UNITED STATES PATENT AND TRADEMARK OFFICE

Office Action Summary	Application No. 10/587,418	Applicant(s) MOENCH ET AL.	
	Examiner VICTOR MACARTHUR	Art Unit 3679

DETAILED ACTION

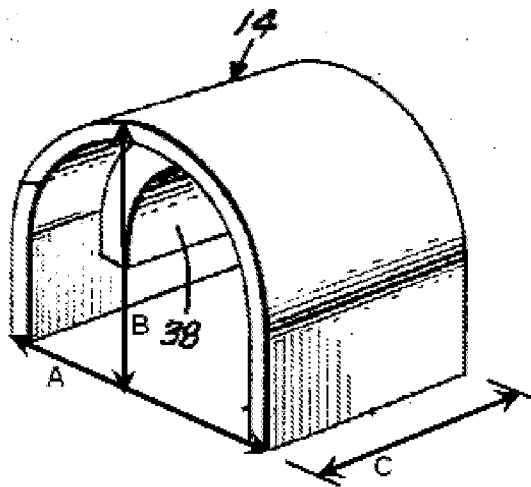
Claims 1-10 are rejected under 35 U.S.C. 102(b) as being anticipated by Zagorski (U.S. Patent 3,401,282) (see marked-up figure below).

Claim 1. Zagorski discloses (Figs.1-6) all of the claimed connecting device structure as follows: a connecting device, comprising: at least one connecting element (14) having an axial

dimension (A) in a direction of an axis (axis of 118), a radial dimension (B) perpendicular to said axis, and a width dimension (C) perpendicular to said axial and said radial dimensions, wherein said width dimension is smaller than said axial dimension and said radial dimension

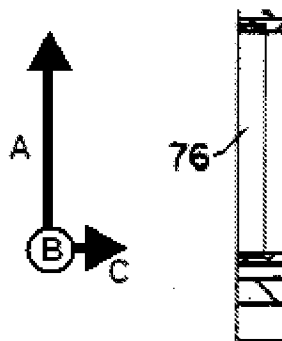
Claims 1 and 12. Henderson discloses (figs.1-6, see marked-up figure above) **all of the claimed connecting device structure as follows:** a connecting device, comprising: at least one connecting element (visco elastic coated springs 36 described in col.2, ll.25-35) having an axial dimension (D) in a direction of an axis (axis extending along D), a radial dimension (E) perpendicular to said axis, and a width dimension (F) perpendicular to said axial and said radial dimensions, wherein said width dimension is smaller than said axial dimension and said radial dimension; and the connecting element is at least partially coated with a viscoelastic material (visco elastic coated springs of col.2, ll.25-35). Furthermore:

Marked-up figure 6

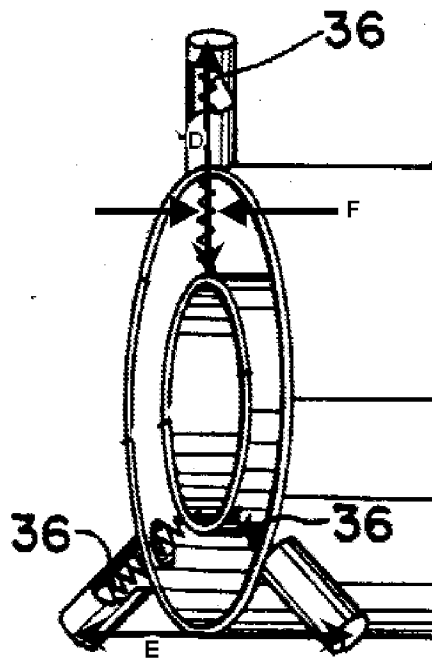
Claims 1 and 11. Henderson discloses (figs.1-6, see marked-up figure 6 above) **all of the claimed connecting device structure as follows:** a connecting device, comprising: at least one connecting element (plastic rings 76 and 78 described in col.7, ll.60-63) having an axial dimension (dimension of 76 along A) in a direction of an axis (A), a radial dimension (dimension of 76 along C) perpendicular to said axis, and a width dimension (dimension of 76 along B) perpendicular to said axial and said radial dimensions, wherein said width dimension is smaller

than said axial dimension and said radial dimension; and the connecting element is at least partially comprised of an elastic plastic (plastic rings of col.7, ll.60-63). Note that all plastics inherently have some degree of elasticity. Furthermore:
